1520-CENTRAL-AVENUE-SE
SITE-DEVELOPMENT-PLAN-FOR-PERMIT
ALBUQUERQUE-NEW-MEXICO
PROJECT#-1520

SITE DEVELOPMENT PLAN FOR BUILDING PERMIT

A PROPOSED PLAN
 FOR
"The Cube Restaurant"
 (1520 CENTRAL AVE. S.E.)
 ALBUQUERQUE, NEW MEXICO
 DECEMBER, 2006

1520-CENTRAL-AVENUE-SE
ELEVATIONS
ALBUQUERQUE-NEW-MEXICO
PROJECT#-1520

SHEET NUMBER
C-1

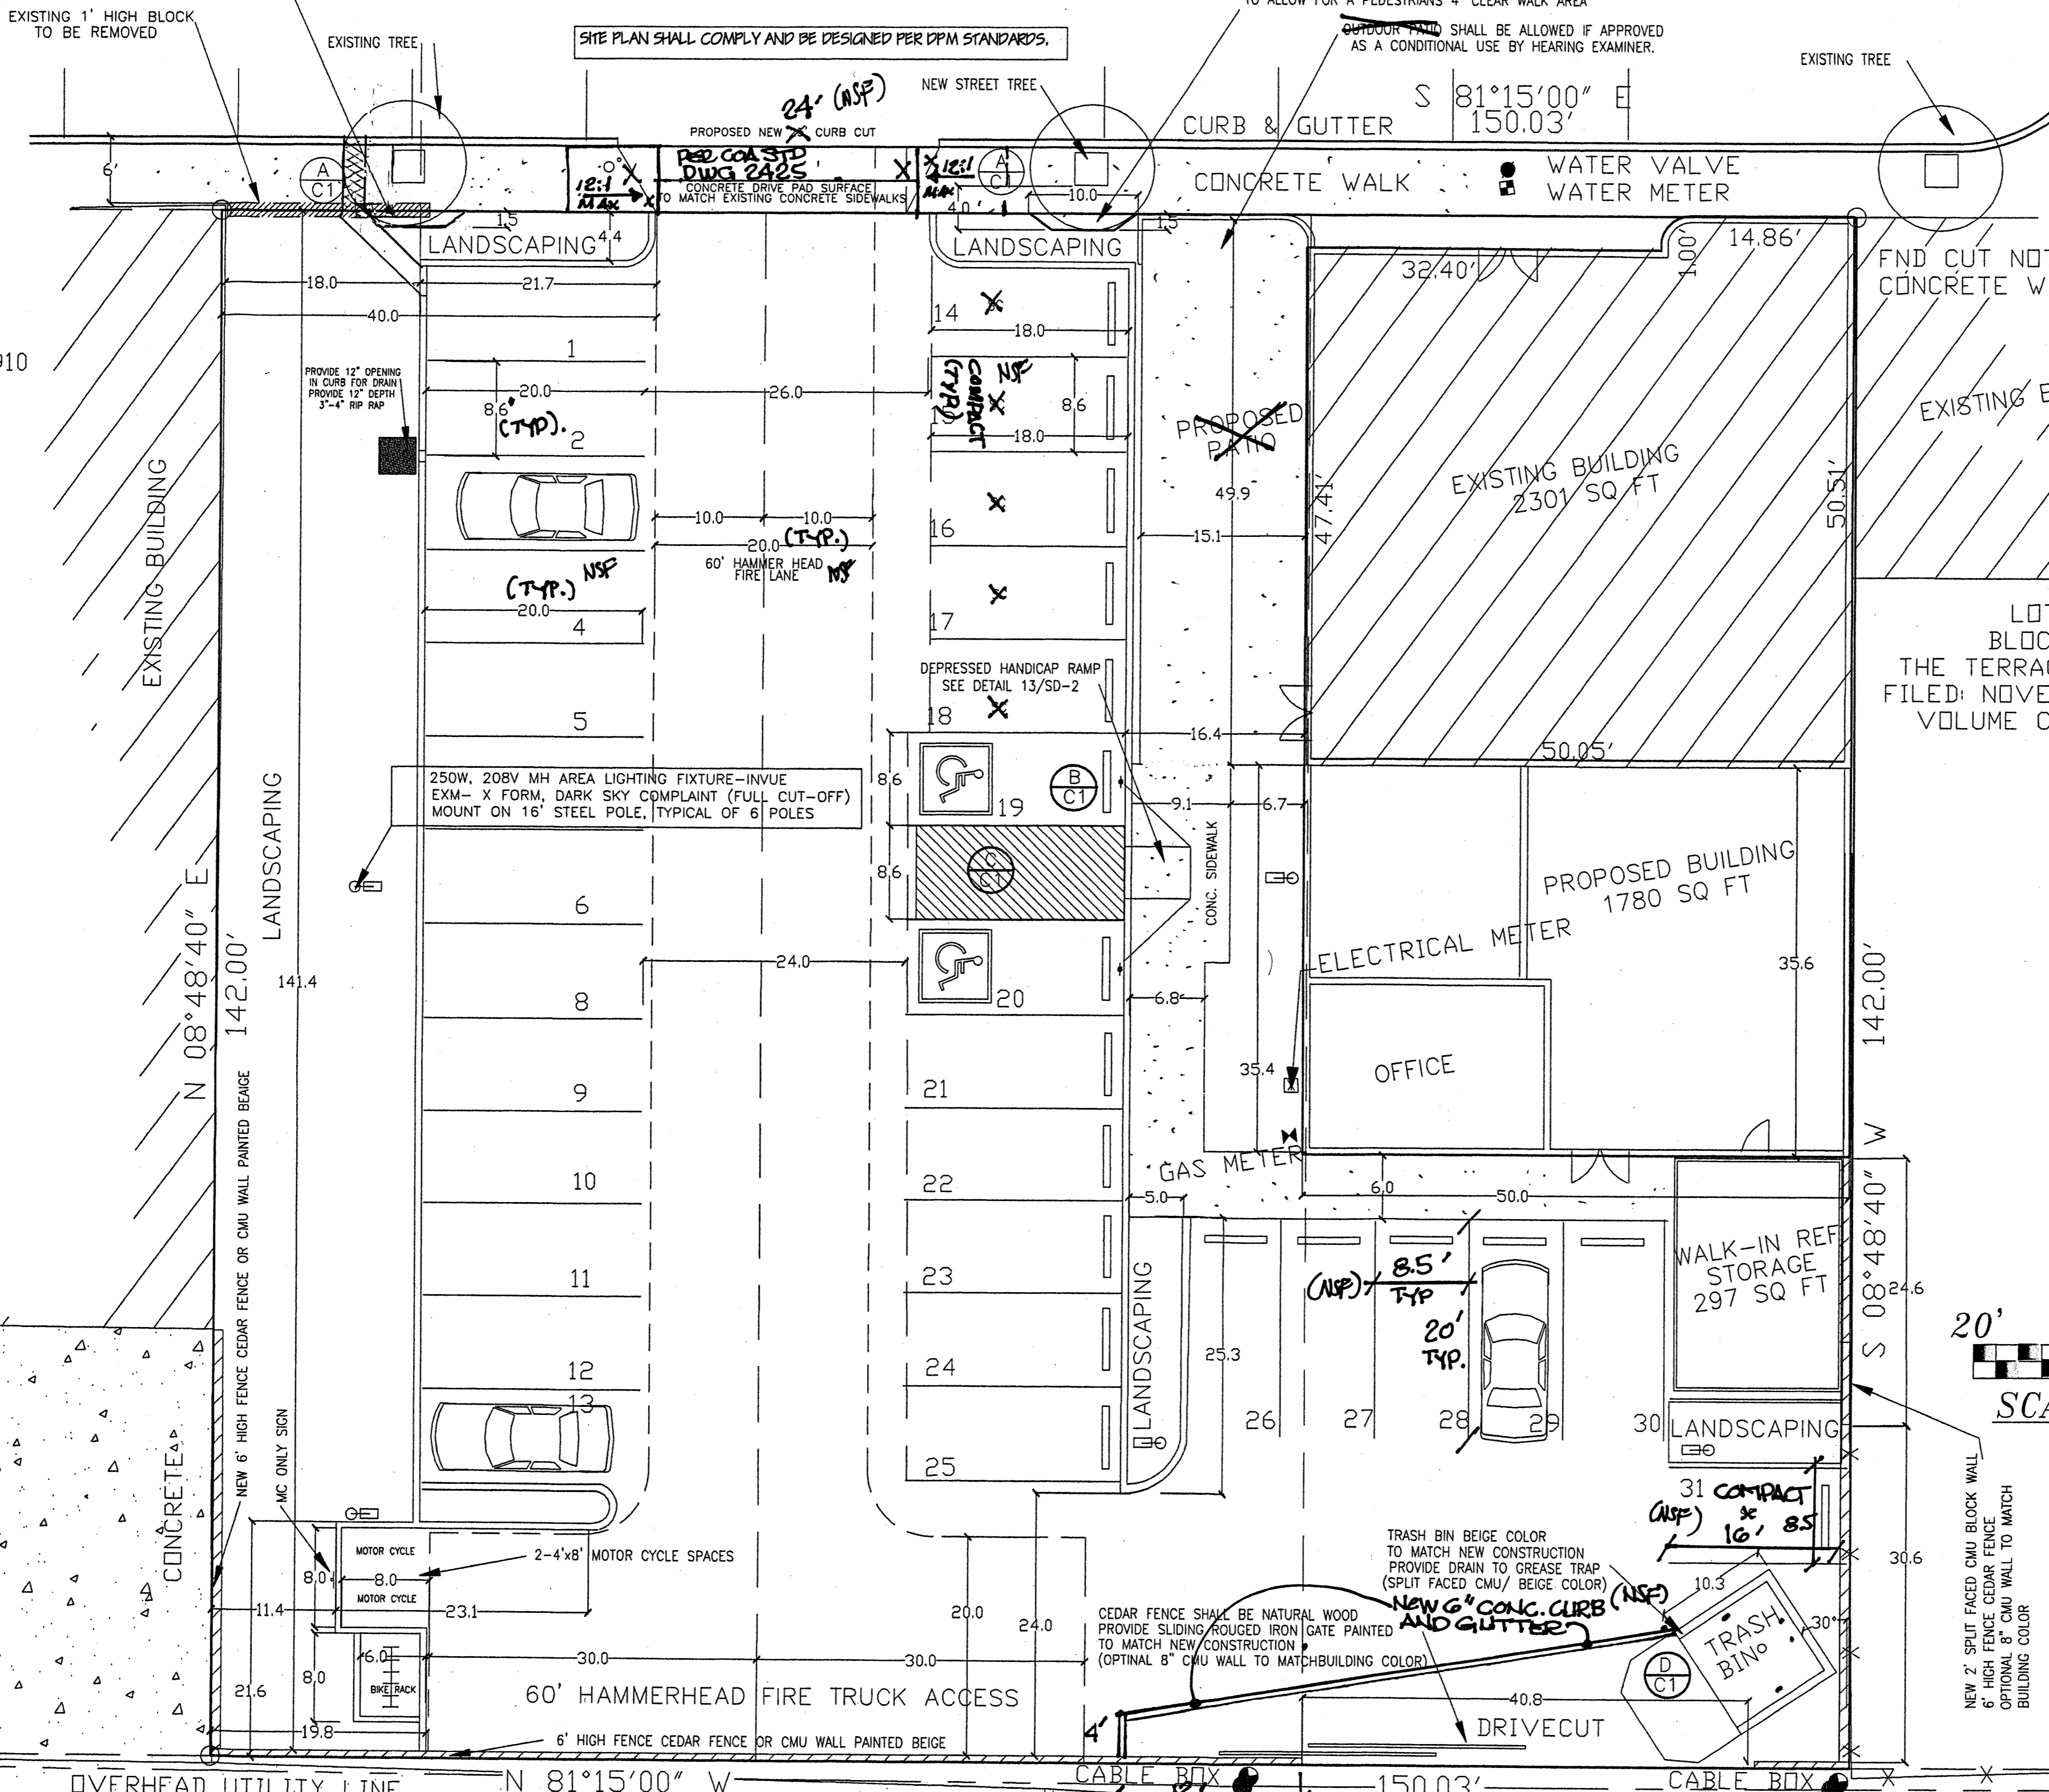
PROVIDE NEW 4" THICK CONCRETE APRON TO ALLOW FOR A PEDESTRIANS 4' CLEAR WALK AREA

PROVIDE NEW 4" THICK CONCRETE APRON TO ALLOW FOR A PEDESTRIANS 4' CLEAR WALK AREA

SITE PLAN SHALL COMPLY AND BE DESIGNED PER DPM STANDARDS.

OUTDOOR PAID SHALL BE ALLOWED IF APPROVED AS A CONDITIONAL USE BY HEARING EXAMINER.

REVISION DATE	11-28-07
DATE	03-11-08
SHEET NUMBER	S-1

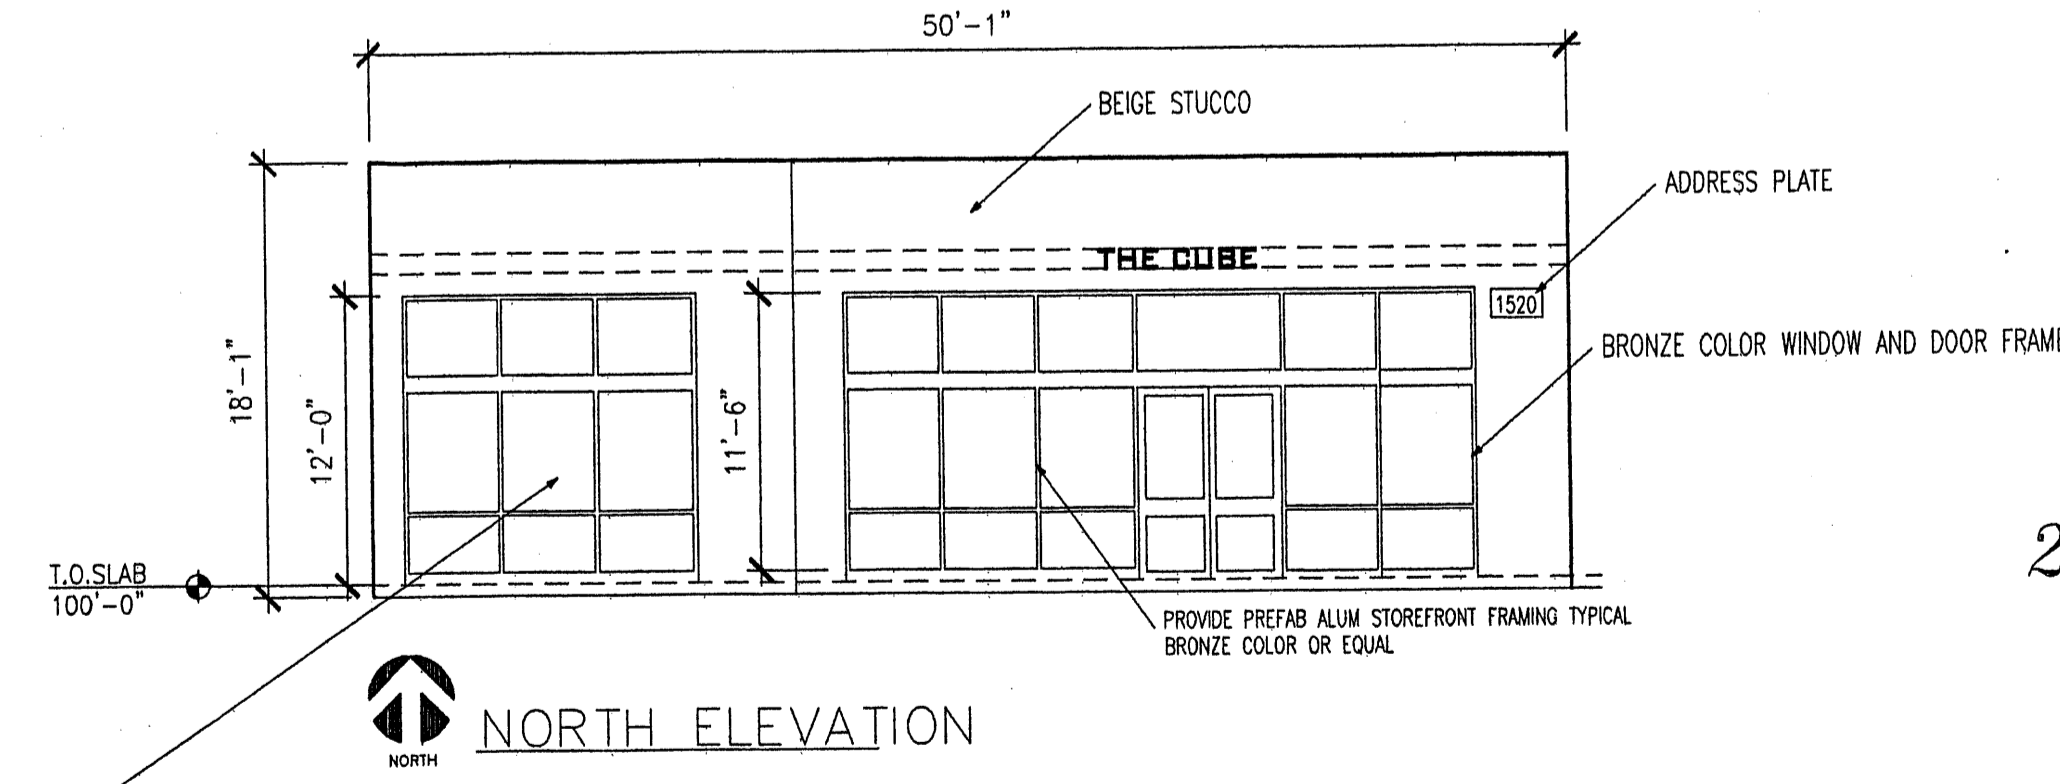
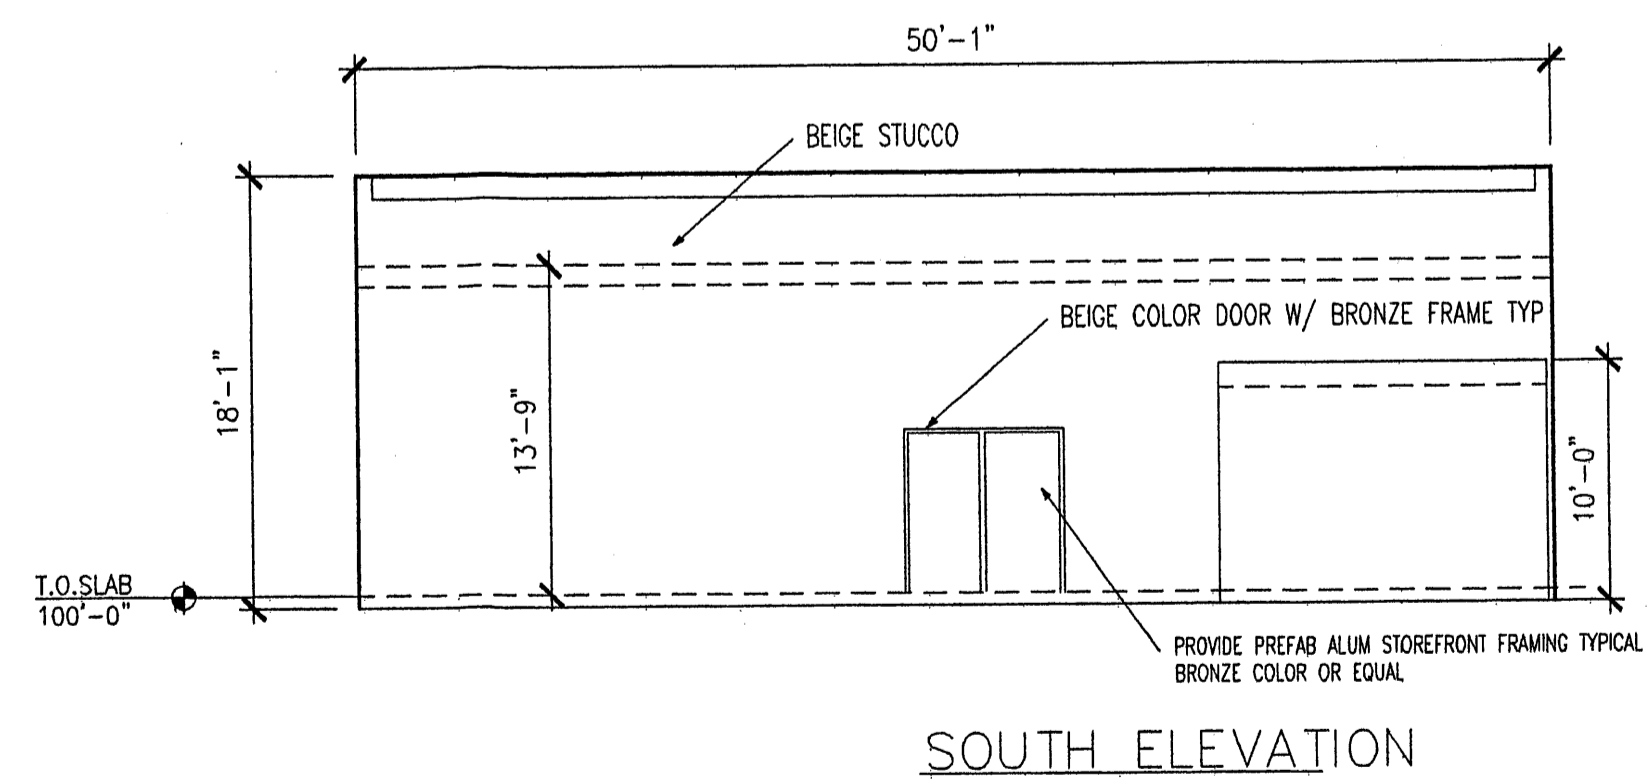
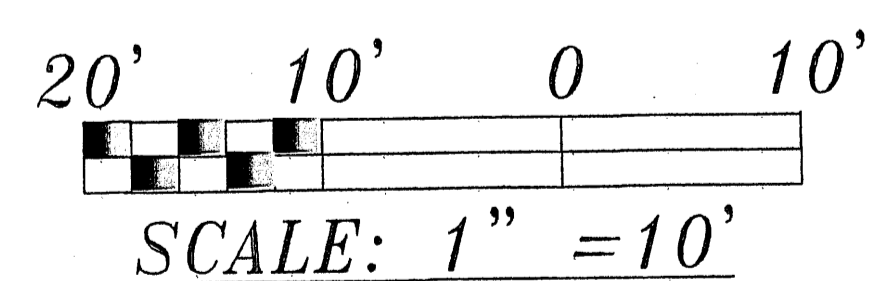
THE NORTHERN MOST BANK OF WINDOWS ON THE WEST SIDE MAY BE GLAZED ROLL UP DOOR IN LIEU OF FIXED WINDOWS. CLEAR GLAZING SHALL BE USED AT WINDOWS FACING CENTRAL.

CLEAR GLAZING SHALL BE USED AT WINDOWS FACING CENTRAL.
